REVIEW OF GLENDELL CONTINUED OPERATIONS PROJECT MINE PLAN AND MINE PLAN OPTIONS

REPORT TO:	Matthew Sprott Director Resource Assessments NSW Department of Planning, Industry & Environment 320 Pitt Street Sydney NSW 2000
REPORT ON:	Review of Glendell Continued Operations Project Mine Plan and Mine Plan Options
DATE OF ISSUE:	28 October 2020
MINECRAFT PROJECT NO:	K2006
AUTHOR:	J Jamieson – FAusIMM, ARMIT (Mining)
CONTACT:	8 / 12 Endeavour Boulevard North Lakes QLD 4509 Telephone: (07) 3482 3664 Web: minecraft.com.au Email: mcc@minecraft.com.au

Figure 5.1 PMP Footprint in Relation to Major Geological Features

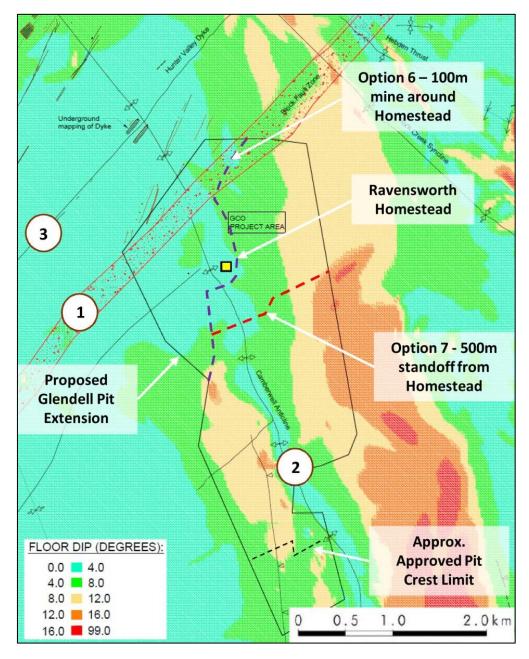
The first two of these features along with consequent smaller throw faulting steeply dipping floors add a significant degree of mining difficulty and will add to the coal loss and dilution that will take place as the mining operations proceed to the North.

As geological complexity increases in the PMP, the above coal loss and dilution assumptions may prove to be optimistic in the areas of steeply dipping seams near the Camberwell Anticline axis and as mining proceeds into the Hunter Valley Block Fault Zone.

Figure 12.1 Working Around Ravensworth Homestead (200m buffer) and Not Mining York's Creek

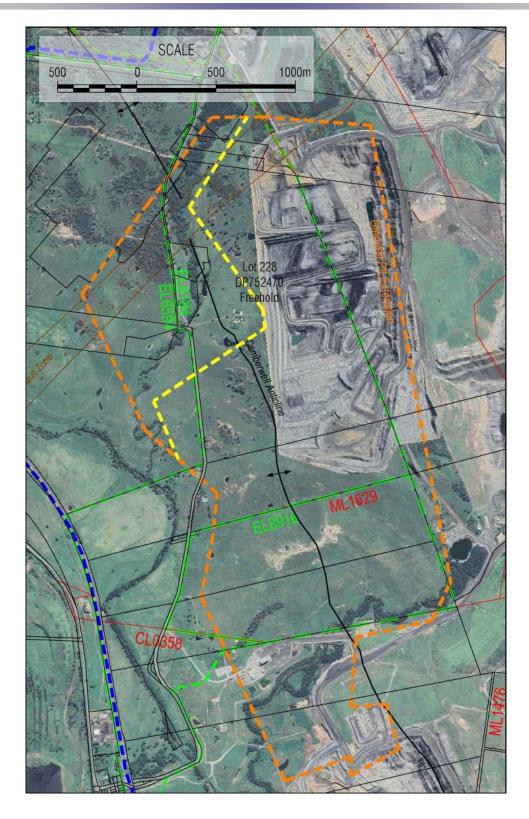
MineCraft submits that in a low coal price regime similar to that currently pertaining, the value of coal recovered from beneath the Ravensworth Homestead complex will be lower than envisaged in the EIS Appendix 30 Economics, and the alternative of mining around the homestead and additionally not mining York's Creek as shown in Figure 12.1 could be evaluated further by Glencore.

As a means of gauging just how much room there is mining around the Ravensworth Homestead to the East, the footprint of the current Glendell Pit is included in the Figure 12.1. It is appreciated this is a shallower operation than the planned PMP, which is designed to mine down to the predominately thermal coal Hebden Seam.

Figure 12.1 confirms that both a 200-300 meter buffer zone and a significant mining operation will fit to the East of the Ravensworth Homestead complex.

The design concept shown in Figure 12.1 has additional benefits in that any required changes to York's Creek would not be necessary and any changes to Hebden Road alignment would be minimised.

Figure 14.5
Glencore's Final Void Plan at MOC

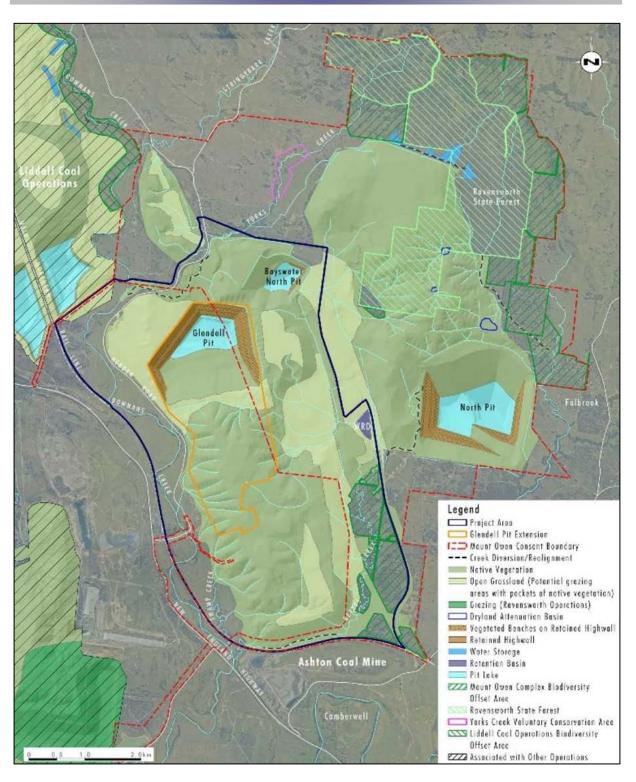
It is noted that there are other nearby voids within proximity to the PMP as operations progress to the North including the West pit currently being used to store tailings (see section C-C in Figure 14.3) and the Bayswater North pit currently being used by Glencore as a water storage.

A waste dumping compromise might be reached where no change to the PMP plan occurs until Mount Owen Mine Operations cease. At that time tailing placement could possibly change from the old West Pit to the Mount Owen void, or part of it, and the West Pit slime dump be contained and capped. A fill buffer would be required to contain the tailings.

These options may not incur any significant haulage cost increases over currently planned PMP dumping costs and may be able to be assessed by further study.

Appendix C Resource on Western Margin of PMP Consumed by Major Haul Road to MIA

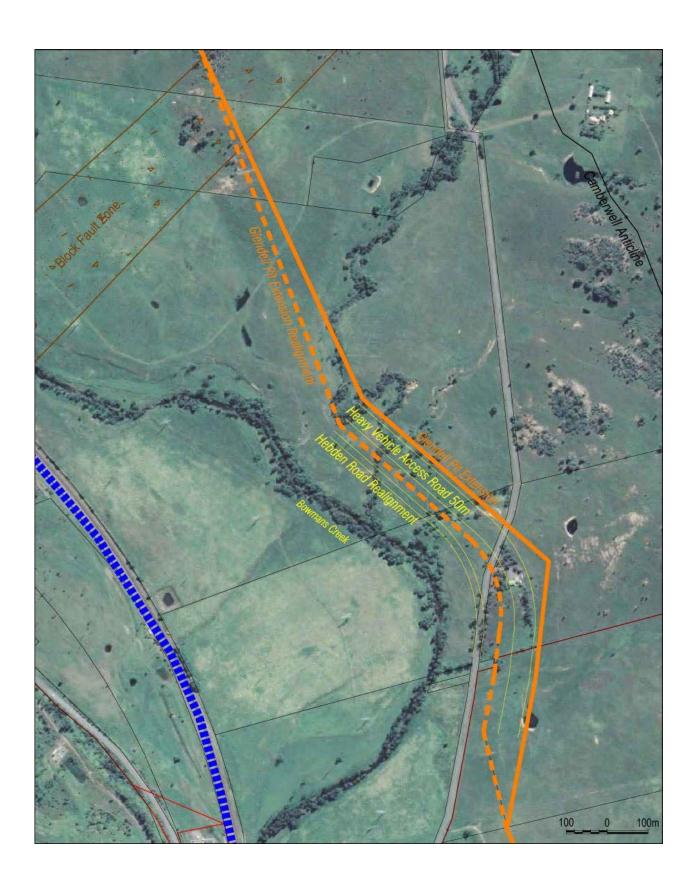
In relation to the overall mine plan, if the MIA could be located to the South, the Western haul road would not be required and the PMP footprint could possibly be pushed further to the West. The tight spot along the Western flank of the PMP is shown in Appendix C.
